***TECHNICAL SPECIFICATIONS
PUBLICATIONS LIST
RECALL CAMPAIGN
SERVICE BULLETIN INDEX***

**328 / 328
GTB / GTS**

Ferrari Servizio Assistenza Tecnica

FERRARI NORTH AMERICA

Fig. 3

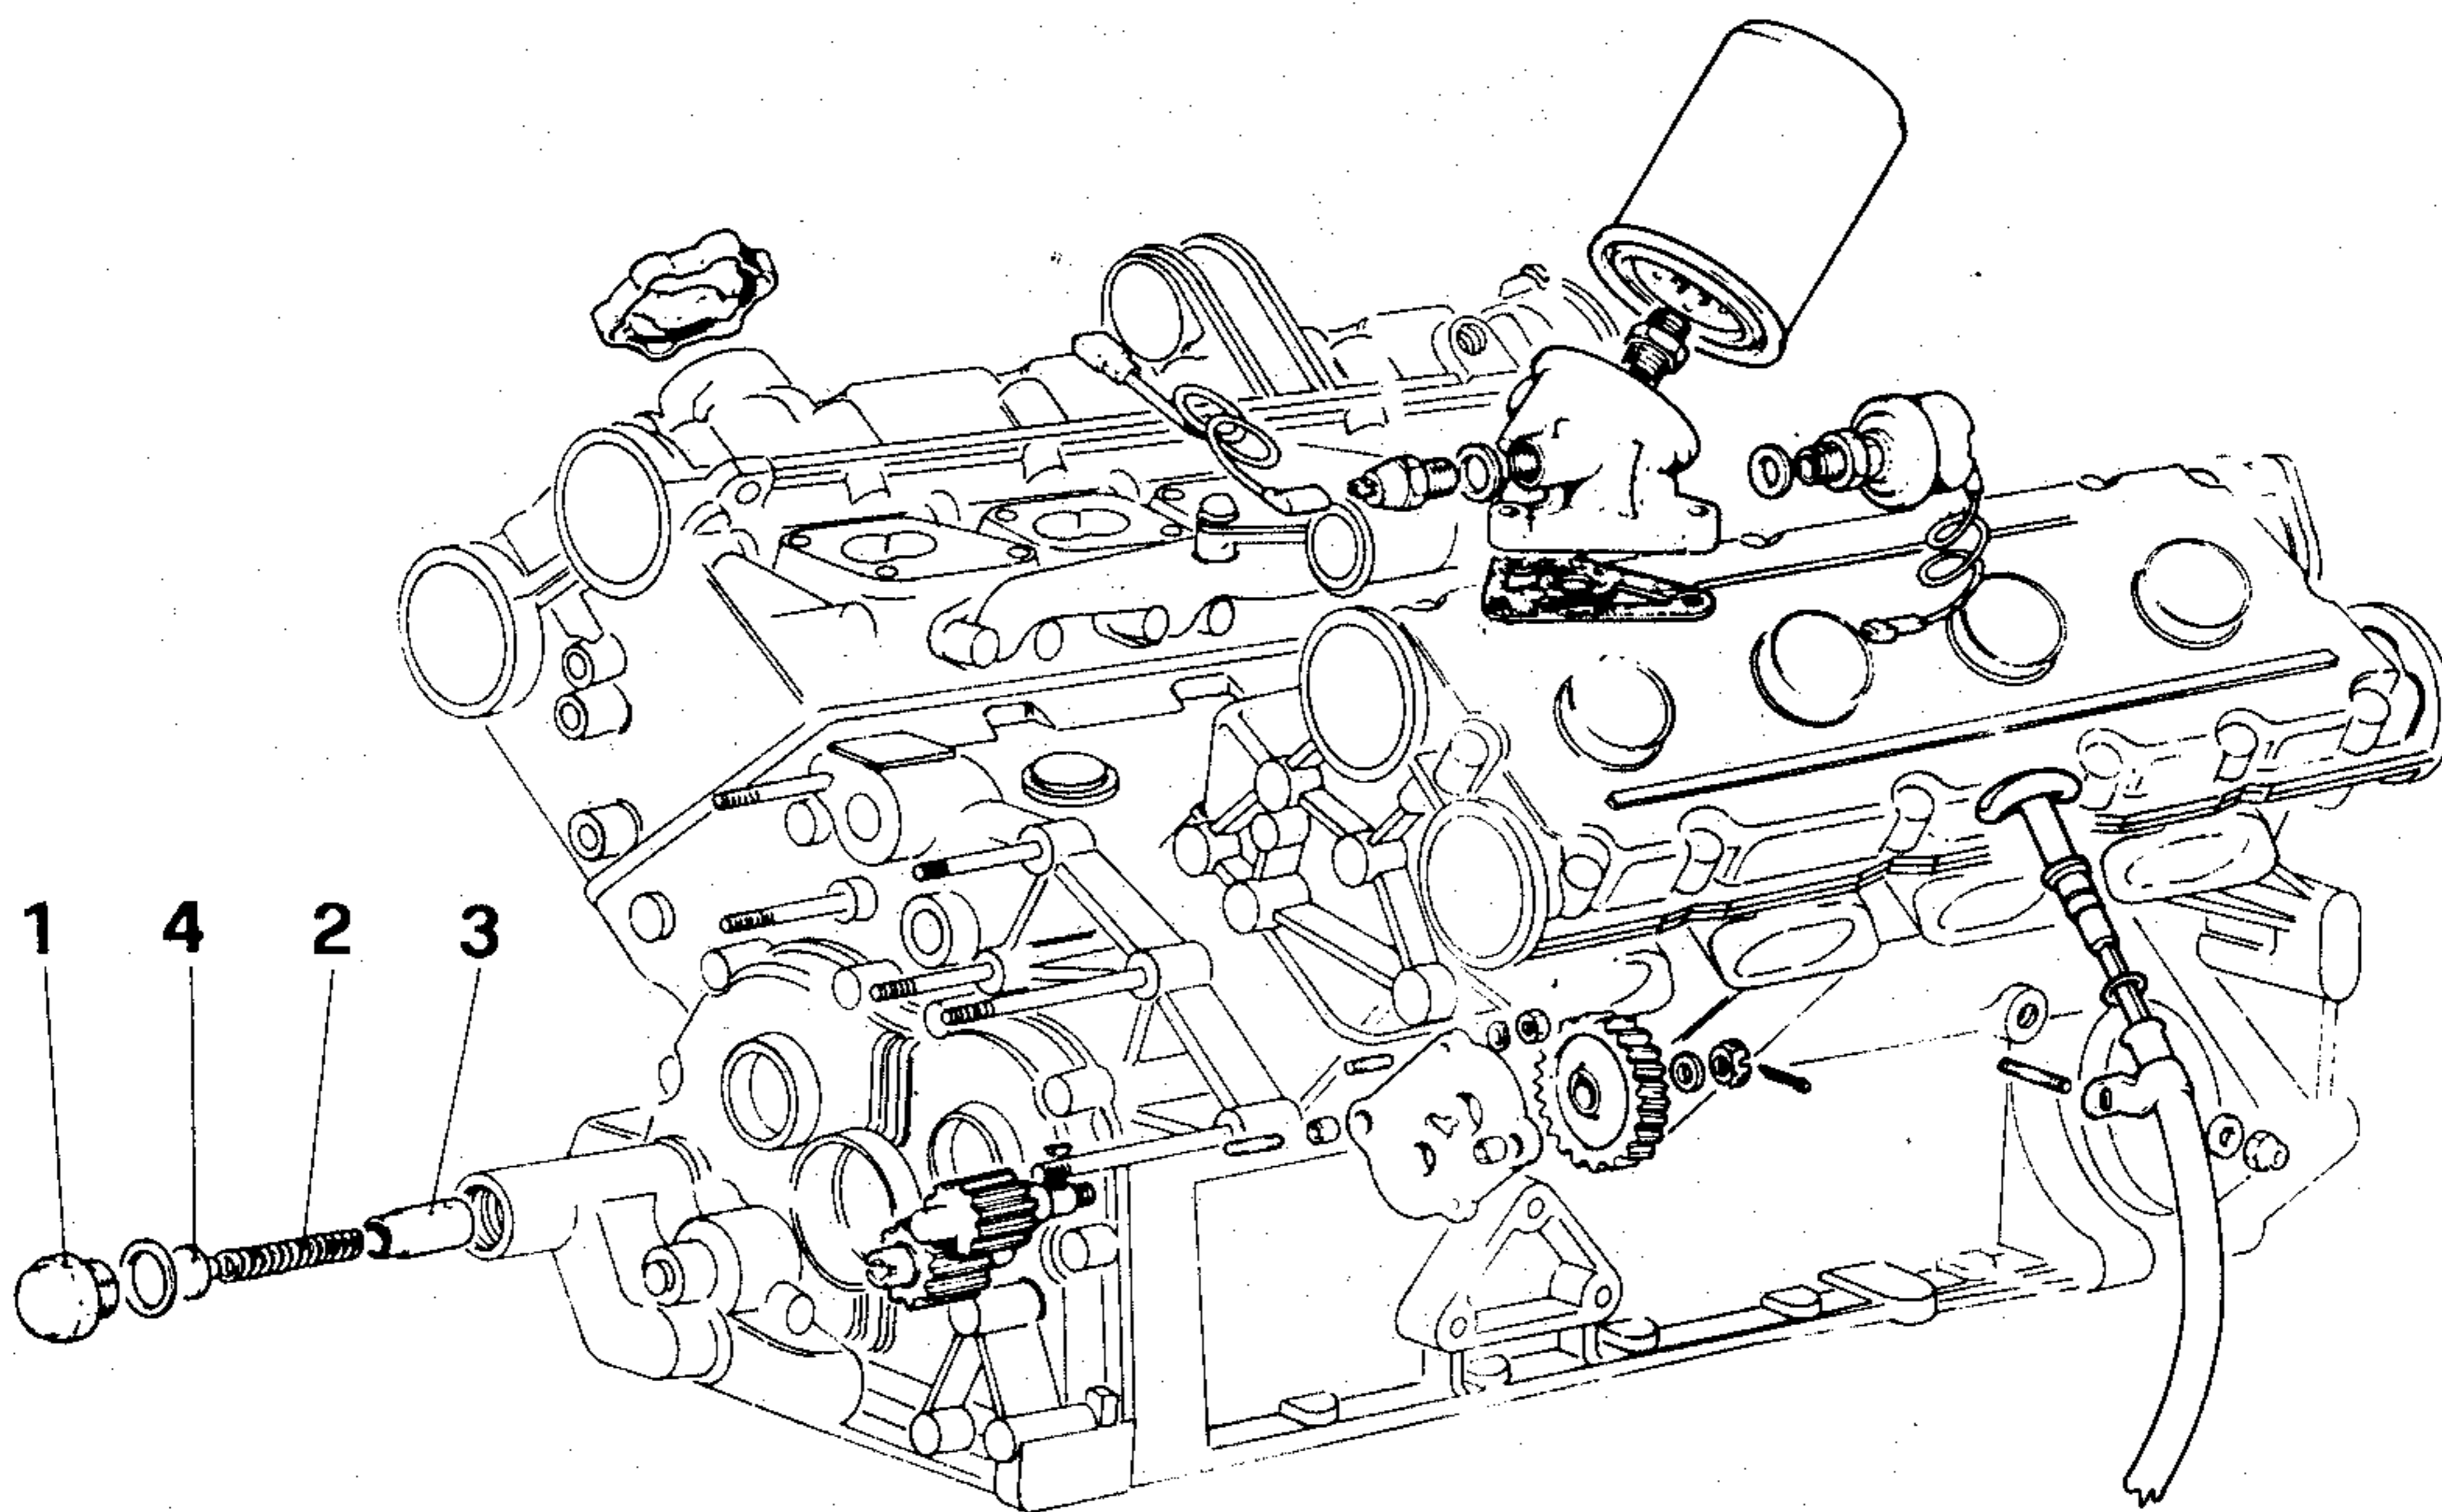
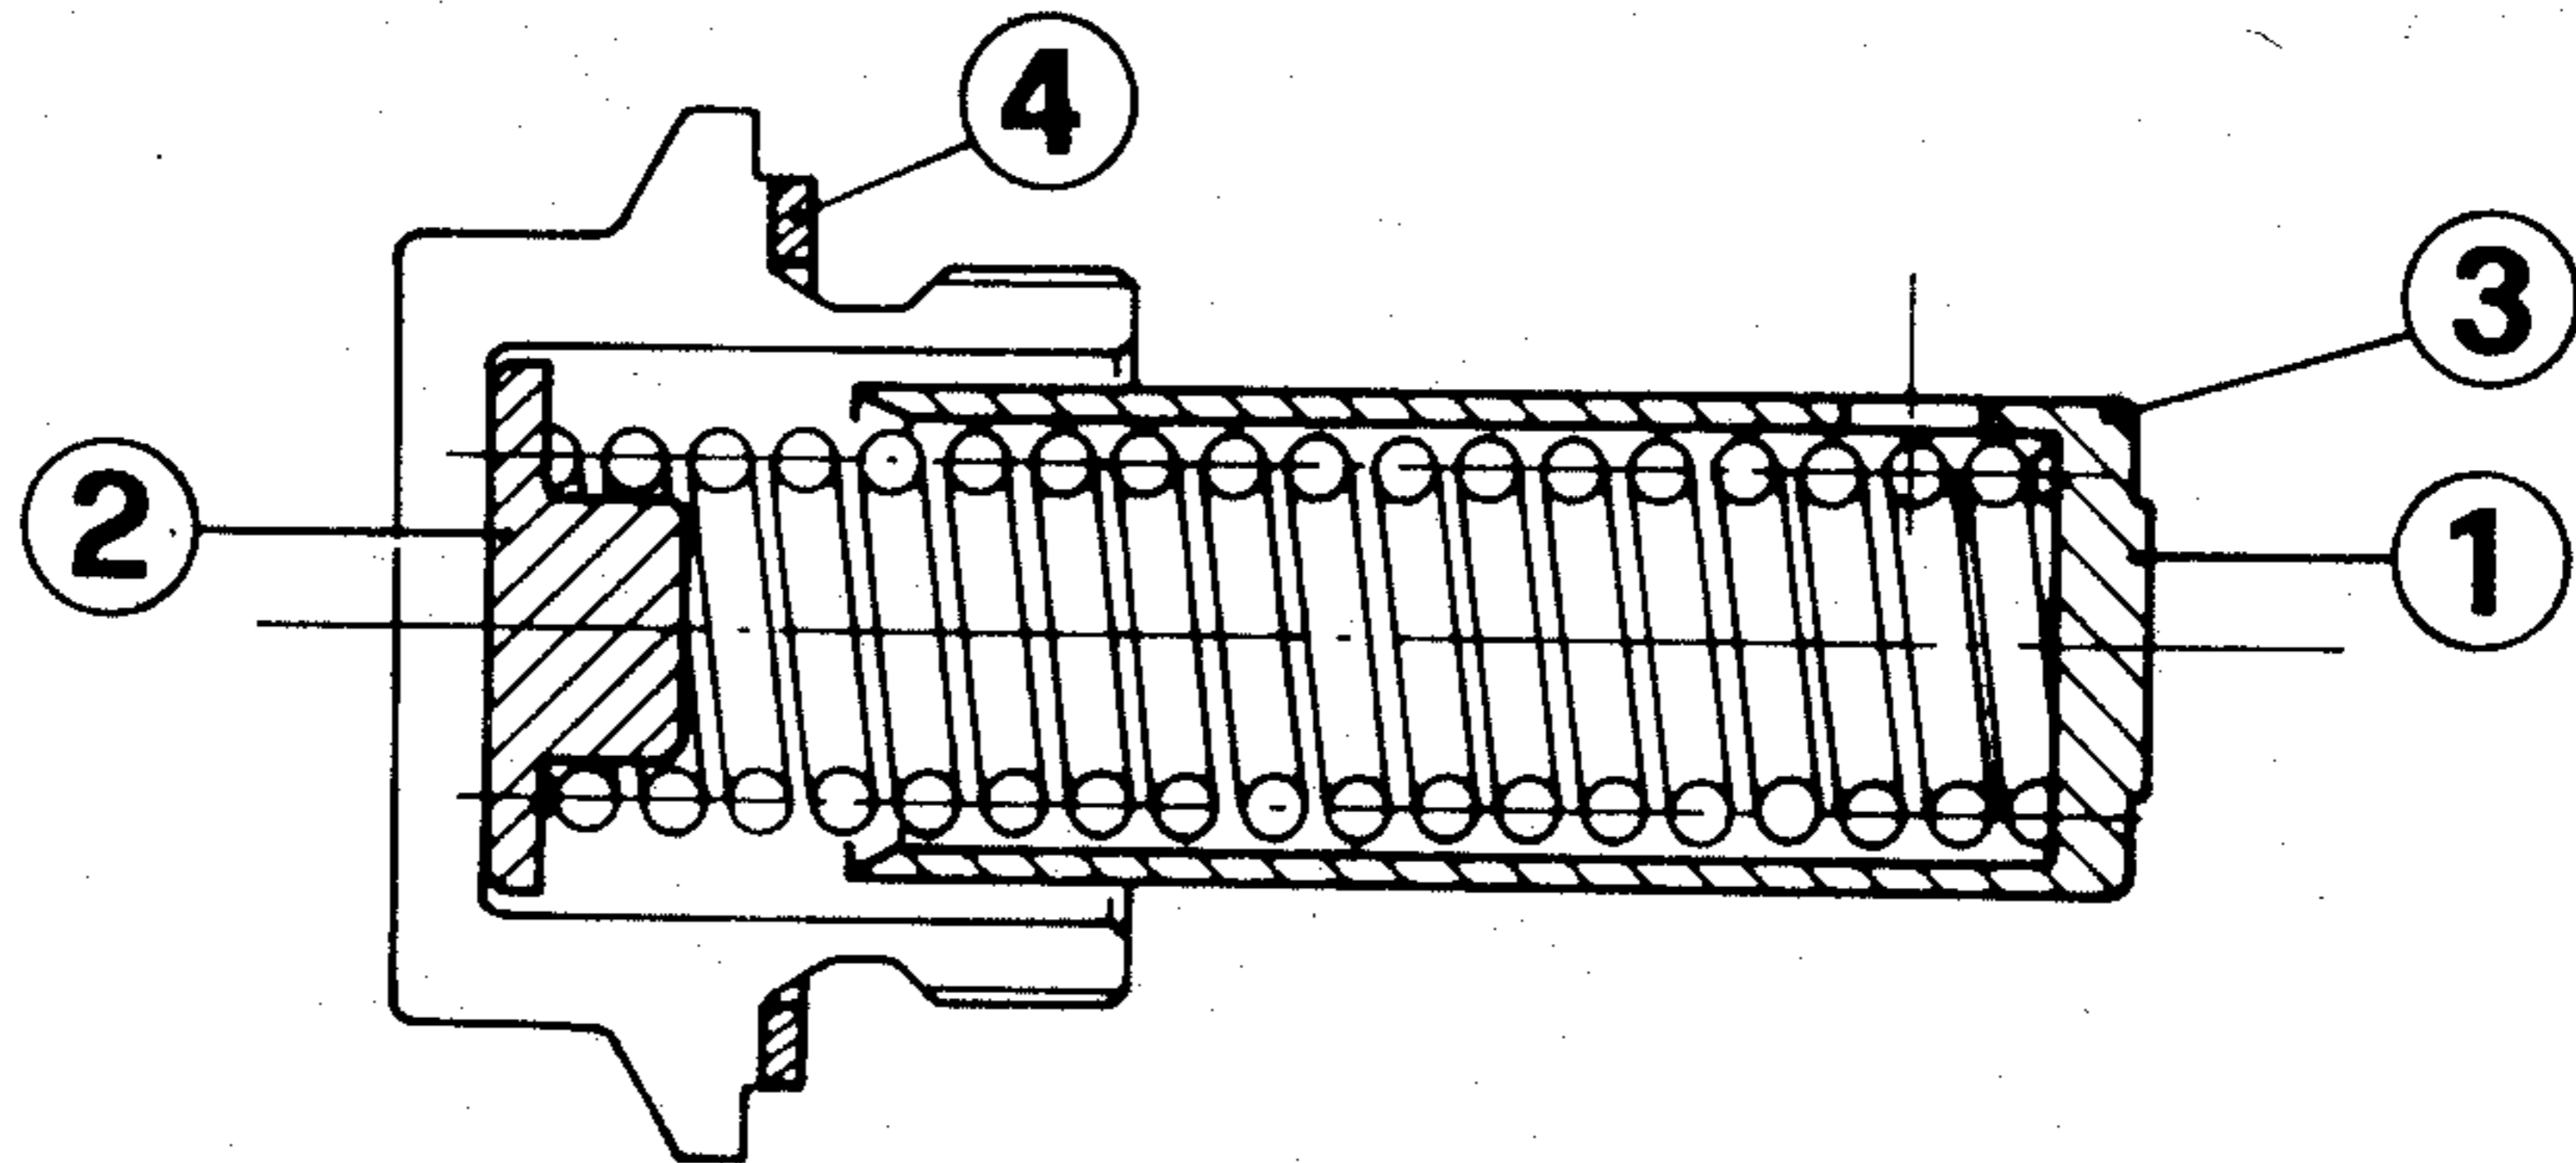
- 1 - With a 32mm wrench, unscrew and remove the cap 1, Fig.2.
- 2 - Remove the spring 2, Fig. 2, and remove the existing control plunger 3, Fig. 2.
- 3 - Remove the spacer 4, Fig. 2 for the spring.
- 4 - Insert the new control plunger 1, Fig. 3, which has the 3 new lateral holes 3, Fig. 3, and check that it slides freely into the sleeve.

- 5 - Insert the new spacer 2, Fig. 3, and verify that the centering portion enters properly the spring as shown in Fig. 3.
- 6 - Reinstall the cap with the proper gasket.
